HEARING DATE: March 26, 2024

SUBJECT: Reveille Ridge Subdivision – AZ, PP  
[H-2023-0050](#)

LOCATION: 7355 S. Eagle Rd., in the east ½ of Section 5, T.2N., R.1E. (Parcels: S1405417400, S1405142100, S1405427800 & S1405131500)

C. Landscape Plan (dated: 12/12/2023)

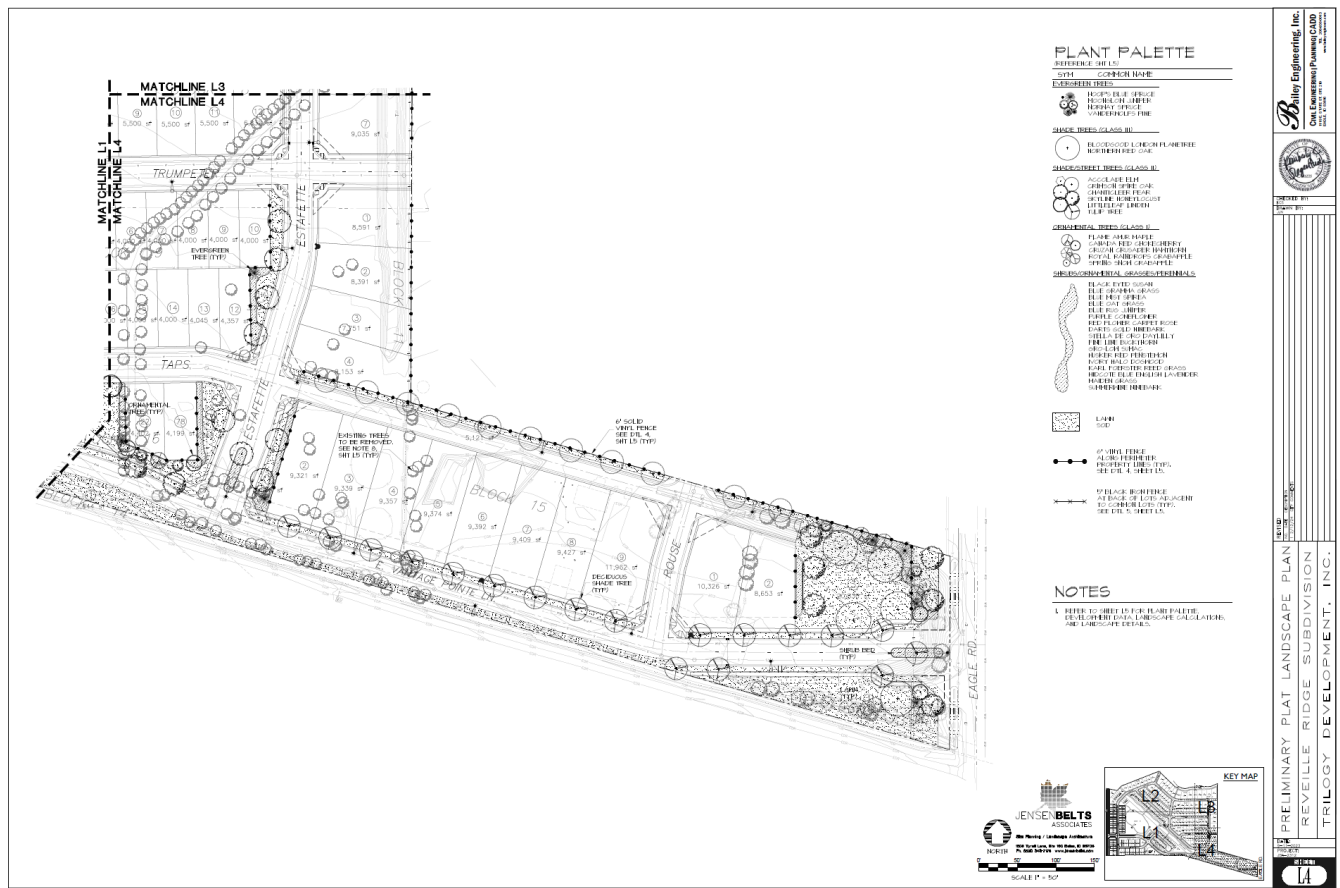
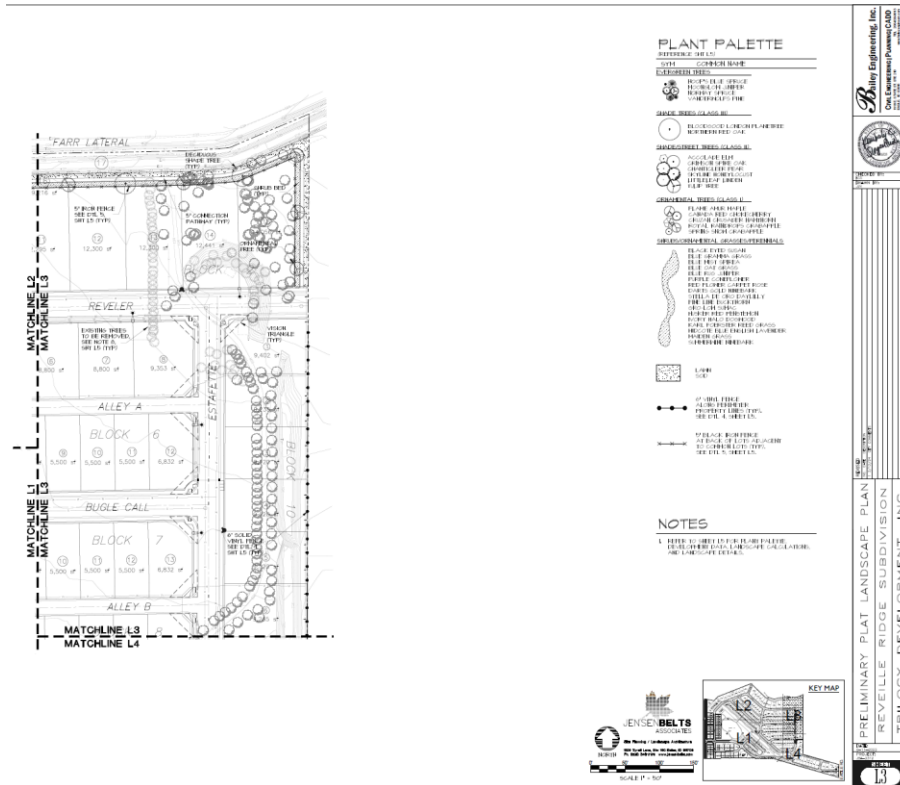
**Landscaping, including trees and shrubs, should be depicted on the landscape plan within the 5' wide landscape strip on each side of all pathways as set forth in UDC [11-3B-12C](#). Note: Alternative compliance may be requested for the trees along the pathway in the Williams pipeline easement as set forth in UDC [11-5B-5](#).**

**There are several existing trees on the site – where possible, existing trees should be retained. Mitigation is required in accord with the standards listed in UDC [11-3B-10C.5](#); calculations demonstrating compliance with the aforementioned standards should be depicted on the landscape plan.**

**Fencing:** All fencing is required to comply with the standards listed in UDC [11-3A-6C](#) and [11-3A-7](#), as applicable. The landscape plan depicts a mix of 6’ tall vinyl privacy fencing and 5’ tall wrought iron fencing.

**Because there is a common lot with a pathway planned in Vertex Subdivision along the northern boundary of the site, Staff recommends the fencing in this location is changed to 5’ tall wrought iron fencing to match that on the north side of the pathway and that proposed on this site to the east along the Farr Lateral in accord with UDC [11-3A-7A.7b](#).**

- g. Change the fencing type along the northern boundary on the western portion of the site adjacent to the common open space with a pathway in Vertex Subdivision to 5-foot tall wrought iron fencing in accord with UDC [11-3A-7A.7b](#).

- j. Include a detail for the picnic areas on Lot 1, Block 16 that includes tables, benches, landscaping and a structure for shade to demonstrate compliance with UDC [11-3G-4C.5](#).

- m. Depict a 5-foot wide landscape buffer planted with shrubs, lawn or other vegetative groundcover along the southwest side of the common driveway on Lot 51, Block 16 in accord with UDC [11-6C-3D.5](#).
